Model: Model K-P3		Date: 14-Nov-03	No.: RG091001
Subject: Service Manual Correction		Prepared by: A. Ishiyama	
From: 1st Technical Support sec. Service Support Dept.			
Classification:	<input type="checkbox"/> Troubleshooting <input type="checkbox"/> Mechanical <input type="checkbox"/> Paper path <input type="checkbox"/> Other ()	<input type="checkbox"/> Part information <input type="checkbox"/> Electrical <input type="checkbox"/> Transmit/receive	<input type="checkbox"/> Action required <input checked="" type="checkbox"/> Service manual revision <input type="checkbox"/> Retrofit information

Model: Model K-P3		Date: 26-Apr-04	No.: RG091003
Subject: Engine Board		Prepared by: A. Ishiyama	
From: 1st Technical Support Sec. Service Support Dept.			
Classification:	<input type="checkbox"/> Troubleshooting <input type="checkbox"/> Mechanical <input type="checkbox"/> Paper path <input type="checkbox"/> Other ()	<input type="checkbox"/> Part information <input type="checkbox"/> Electrical <input type="checkbox"/> Transmit/receive	<input checked="" type="checkbox"/> Action required <input type="checkbox"/> Service manual revision <input type="checkbox"/> Retrofit information

Important Not

Minor Modification of old G0885123 Engine Board to its New Version

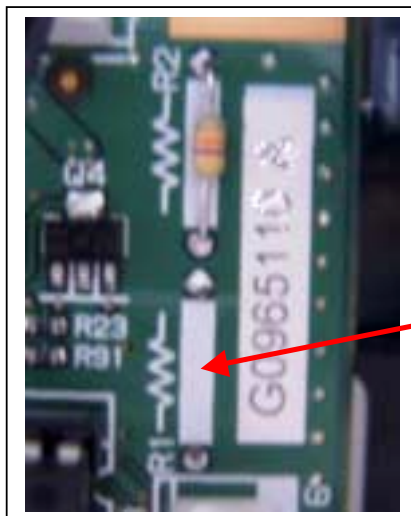
The old engine board (G0885123) contains two resistors, R1 and R2, but the new board for NA (G0885121) contains only R2 and the new board for EU/Asia (G0885122) contains only R1.

1. If the old engine board is already installed in the machine:
 - i) Open the front door.
 - ii) Remove the operation panel (2 hooks, 1 harness).
 - iii) Remove the rear cover and option top cover.
 - iv) Remove the top cover (4 screws).
 - v) Remove the left cover (2 screws).
2. **For NA version**
 Remove R1 as shown below using a pair of wire cutters (nippers).

Remove R1 using a pair of wire cutters

For EU/Asia version

In the same manner, **remove R2 using a pair of wire cutters.**
